# Access Compliance Report

## Public Rights-of-Way

### (Curb Ramps)

Intersection ID: 52246	Main Street: CENTERLINE_DR	Cross Street: KNOX_FARM_RD	Location: SE
ADA ID: 474E6F4B88B9	Ramp Type: Perp	Initial Pass/Fail: Fail	Overall Compliance: No
Severity Score: 22.5			
Codes/Mitigation Info/Possible Solution		Field Measurements/Component Compliance

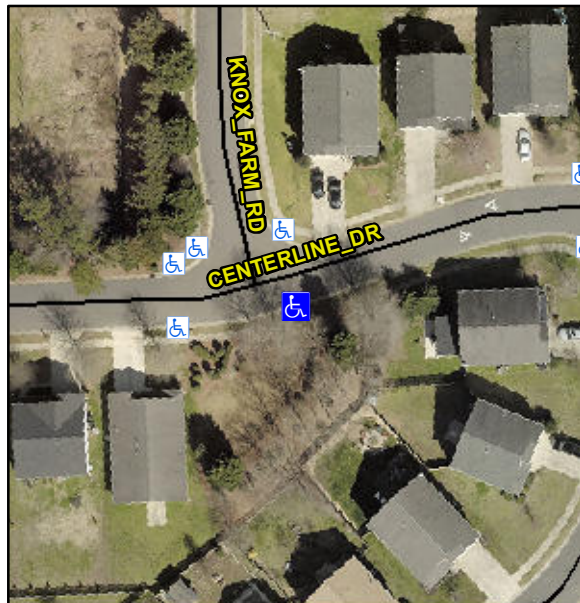
**R304.5.1, R304.2.2, R304.5.3**

Compliance	Description	Data	Compliance	Description	Data
N/A	Ramp Length (in)	47.0	No	Ramp Slope (%)	9.5
No	Ramp Width (in)	47.5	No	Ramp XSlope (%)	2.6
N/A	Flare Type LT	N/A	N/A	Flare Type RT	N/A
N/A	Flare Slope LT (%)	N/A	N/A	Flare Slope RT (%)	N/A
N/A	Flare Traversable LT?	N/A	N/A	Flare Traversable RT?	N/A
N/A	Landing Length (in)	N/A	N/A	DWS Provided?	N/A
N/A	Landing Width (in)	N/A	N/A	DWS Contrast?	N/A
N/A	Landing Slope (%)	N/A	N/A	DWS Length (in)	N/A
N/A	Landing X Slope (%)	N/A	N/A	DWS Full Width?	N/A
N/A	Landing Curb? (Y/N)	N/A	N/A	DWS Offset (in)	N/A
N/A	Shared Landing?	N/A			
N/A	Gutter Ponding?	N/A	N/A	Gutter Slope (%)	N/A
N/A	Gutter Lip Ht (in)	N/A	N/A	Gutter X Slope (%)	N/A
N/A	Painted X Walk1?	No	N/A	Painted X Walk2?	N/A
	X Walk 1 Direction	To N		X Walk 2 Direction	N/A
N/A	X Walk 1 Width (in)	N/A	N/A	X Walk 2 Width (in)	N/A
	X Walk 1 Slope (%)	3.4		X Walk 2 Slope (%)	N/A
	X Walk 1 X Slope (%)	2.0		X Walk 2 X Slope (%)	N/A

**Remove & Replace Entire Ramp.**
